MEMORANDUM

To: Montgomery Township Zoning Board of Adjustment

**Re: Thomas Residence
Bulk Variance**
26 Blue Heron Way
Block 30001, Lot 16.13
R-5 Single Family Dwelling Detached

Date: February 5, 2024

Subject Property Located at 26 Blue Heron Way

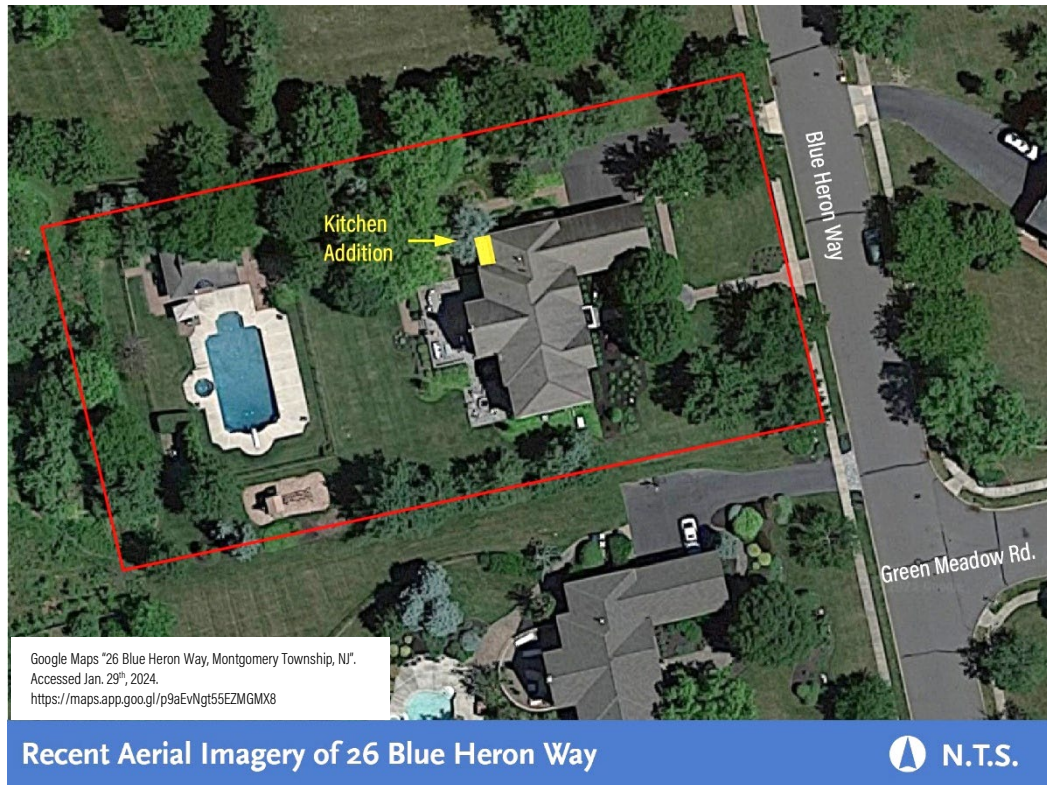
1.2 Some Existing Development May Have Not Received Approval: On page 11 of the application under item 3.A, the applicant states “*The applicant proposed a 6’ x 12’ kitchen addition and then was notified by the Township Construction Department that the existing site conditions exceeded the maximum allowable impervious cover and therefore a variance is required. The owner has indicated they purchased the property in it’s existing condition which has existed without change for years.*” It is unclear at this time what approvals, if any, were obtained for the development of the accessory uses. These include a pool house, swimming pool, and children’s play equipment.

Historic aerials indicate that the lot was developed some time between 1995 and 2002 and was part of a large farm up to at least 1995. The Montgomery Township Zoning Map dated August 5, 1997¹ indicates that when the farmland was subdivided into single-family lots that it was located in the R-2 zone, which may

explain the manner in which the lot was developed. This office also notes that the 2001 Zoning Map² indicates that the site was located in the R-5 zone, indicating the zoning changed sometime between 1997 and 2001. **Understanding the date the dwelling was constructed, the zoning in place at the time of construction, and any subsequent approvals (if any) may be instructive to the Board's decision.**

All of the existing accessory uses are permitted in the zone. If the Board were to approve this application, the Board resolution would memorialize the conditions of the site and provide a legal record for the current and any future property owners of the development located on site. **This office recommends that the applicant provide testimony regarding the interior/use of the pool house if the use was not previously approved. Additional discussion regarding the pool house can be found in 2.2.**

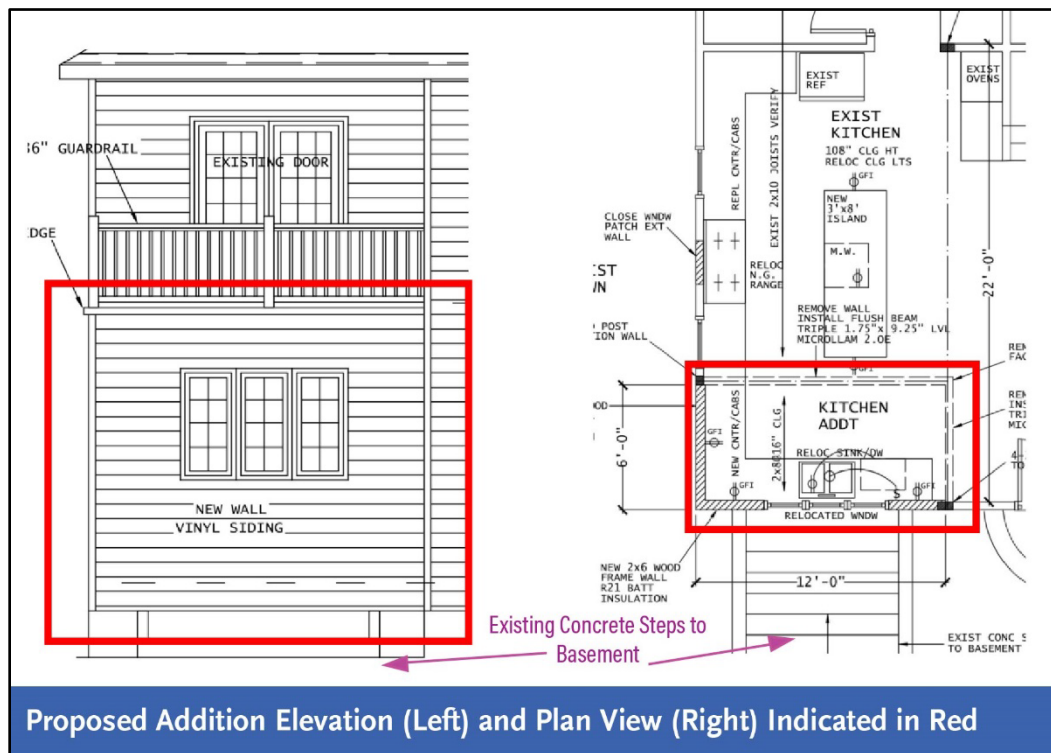
- 3.2 **Description of Addition.** The plans indicate that the addition will extend six feet from the rear/northwestern corner of the building and will be 12 feet in width, though the addition will be flush with the existing building as this will essentially “fill” an existing alcove created by the second floor balcony and basement stairs. The exterior siding will match the existing siding. The roof of the addition will align with the second floor balcony and the floor with the basement steps.

The applicant should provide testimony regarding the basement access and how it may be impacted by the addition.
